DATE: <b>12/19/2017</b>	JOB NO. <b>1808</b>
ATTENTION: <b>Planning Department</b>	
RE: <b>Amended Site Plan Approval</b>	
<b>46 - 64 Maplewood Avenue</b>

## 46-64 MAPLEWOOD AVENUE

**RE: Application for Site Plan Review for 46 – 64 Maplewood Avenue, Portsmouth**

On behalf of 30 Maplewood, LLC, we hereby submit revised plans for the 46 - 64 Maplewood Avenue project for TAC approval. The plan set has been revised to address the comments from the October 31 Technical Advisory Committee meeting. The plans have been revised to reflect the following comments, with response in **bold** text:

**VISIBLE LIGHT INC.**  
**LIGHTING PLAN**

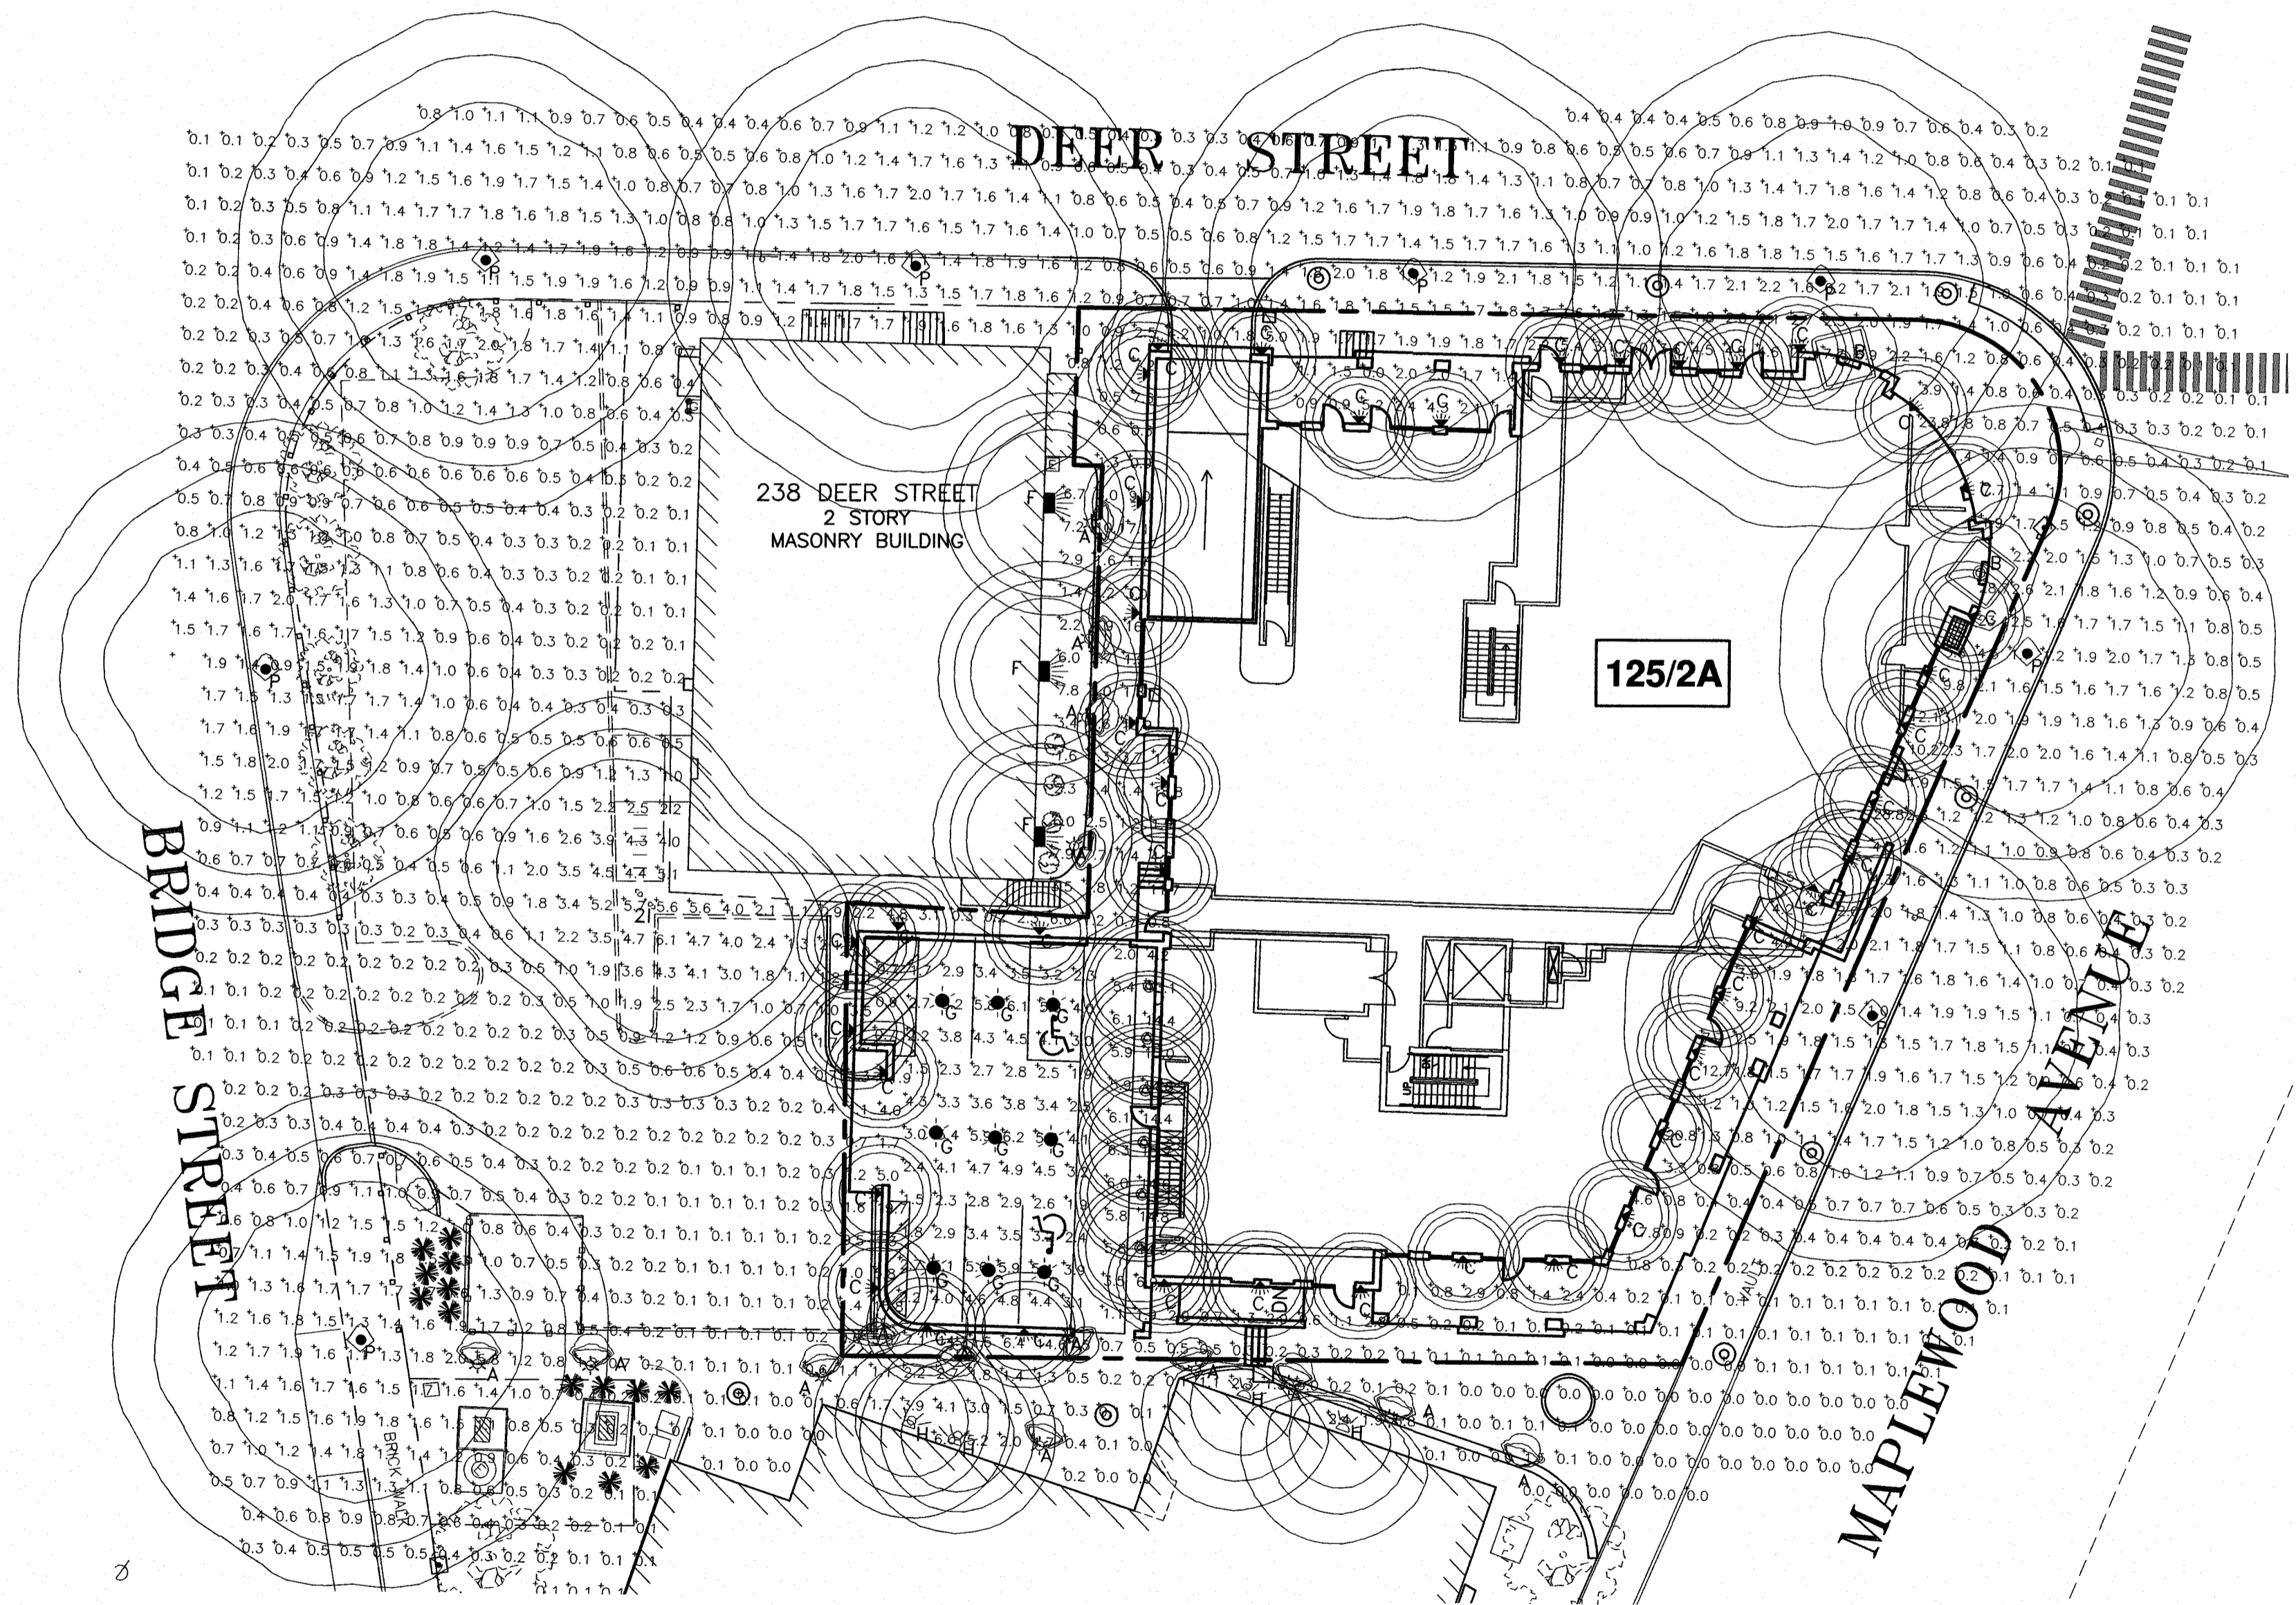
- Please provide a photometric plan. **Sheet L1 has been added to the plan set.**
- Please provide a detail of the wall-mounted exterior lights that you are proposing and indicate where dark sky friendly lighting measures have been incorporated. **See the supplemental information.**

**I DETECTABLE WARNING SURFACE**  
C3 NTS

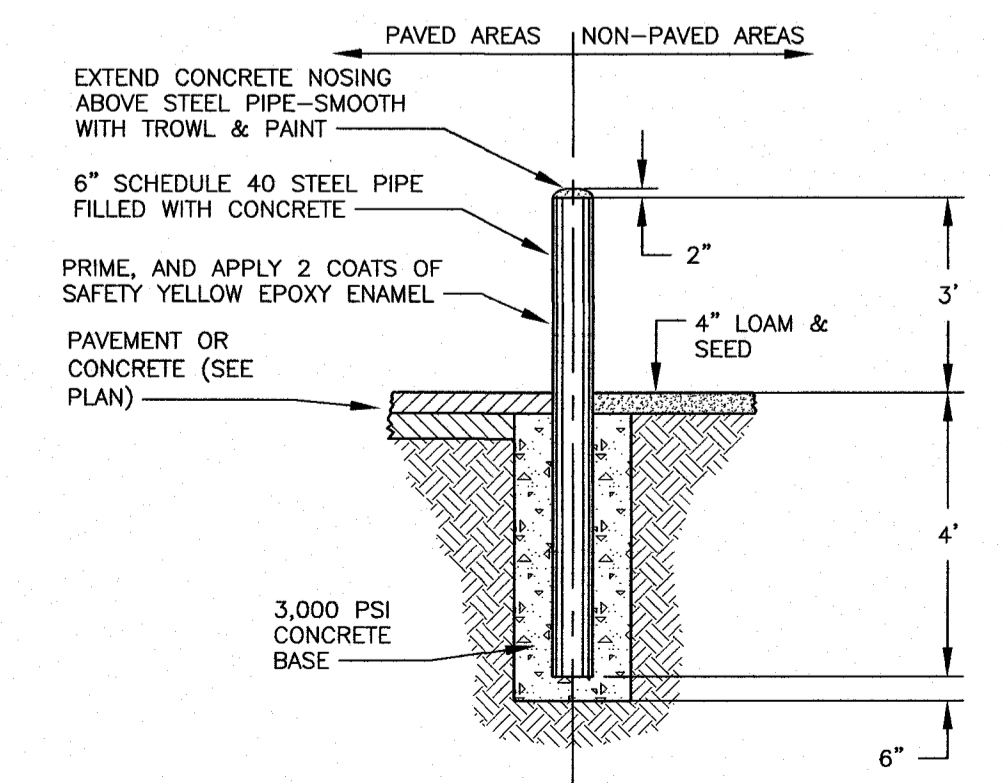
- Sidewalk details should show a maximum cross slope of ¼" per foot. **Comment addressed; See Sheet D2.**
- Detectable warning detail should be as shown and is not necessarily 2'x3'. **Comment addressed; See Sheet D2.**

**O** FIRE HYDRANT INSTALLATION DETAIL PORTSMOUTH NTS

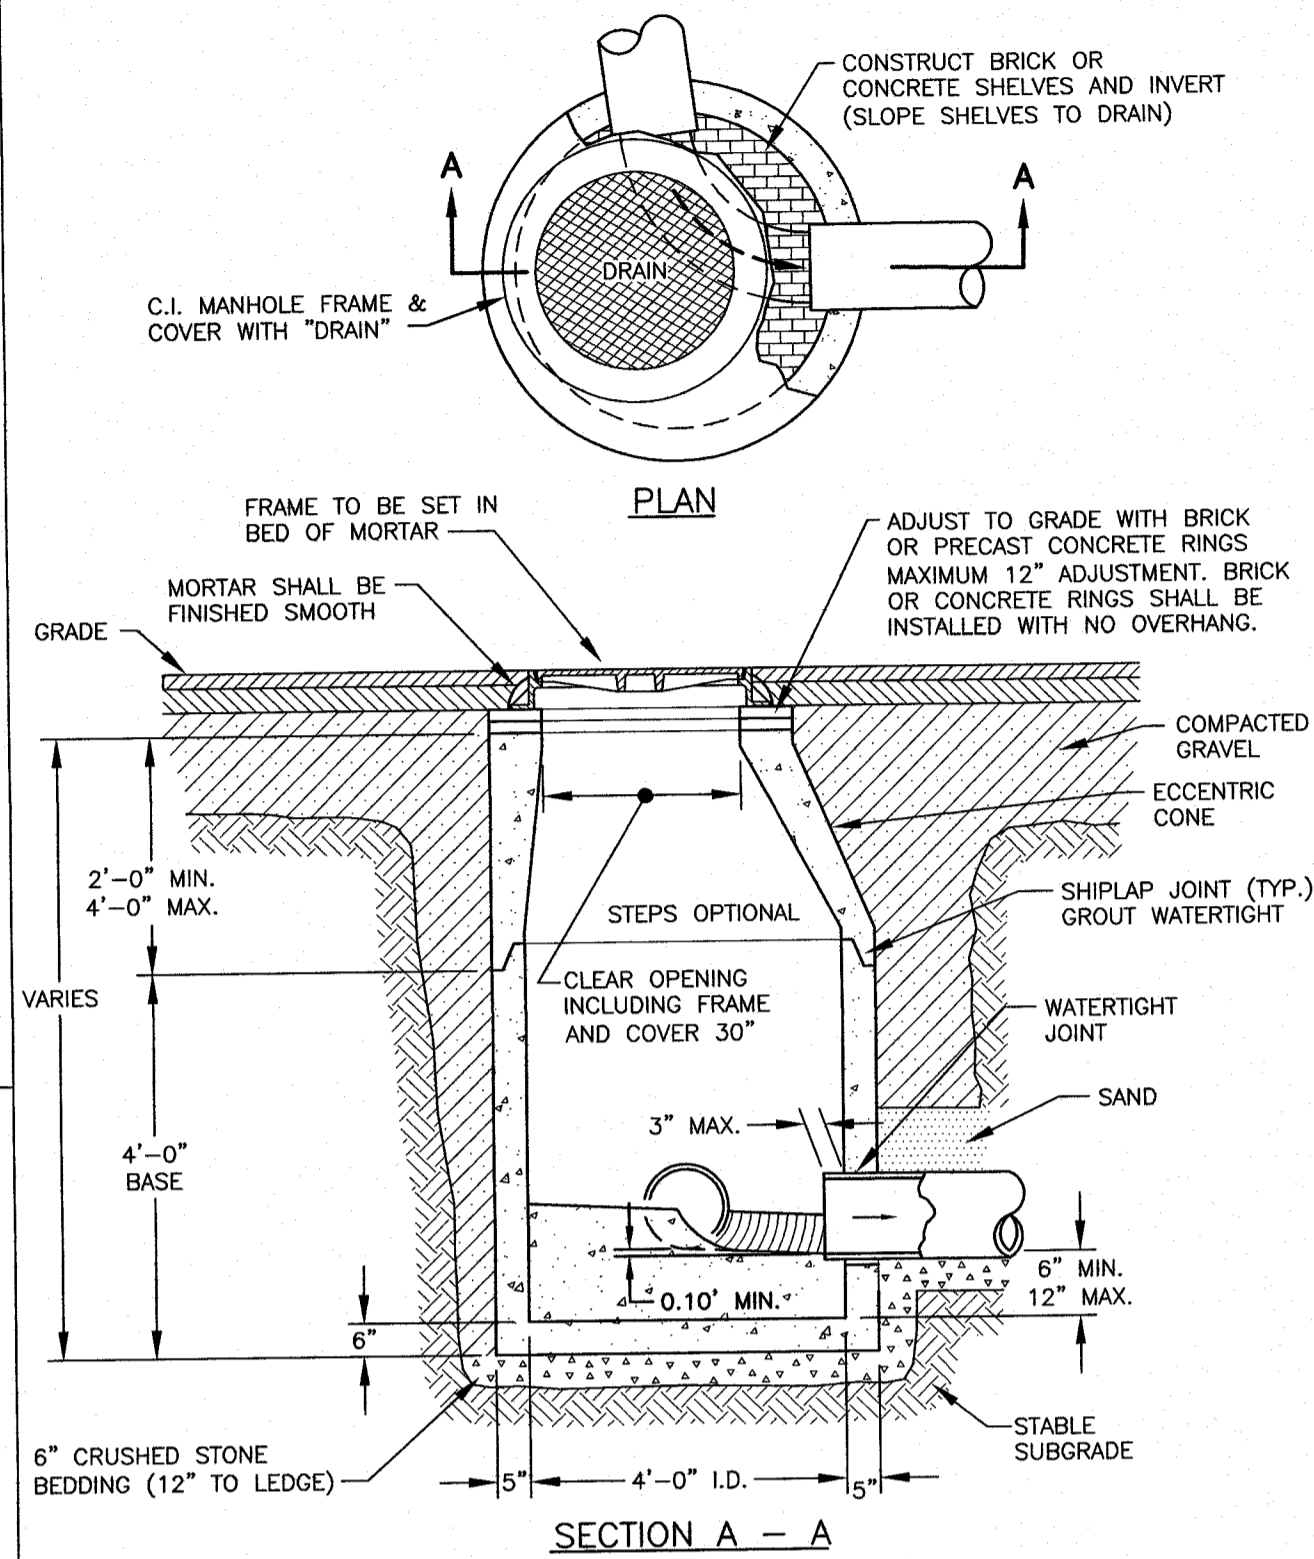
- Provide new hydrant in front of VFW. There can be no drain holes in the new hydrant. This is no longer allowed by AWWA. **The Hydrant Detail has been revised.**
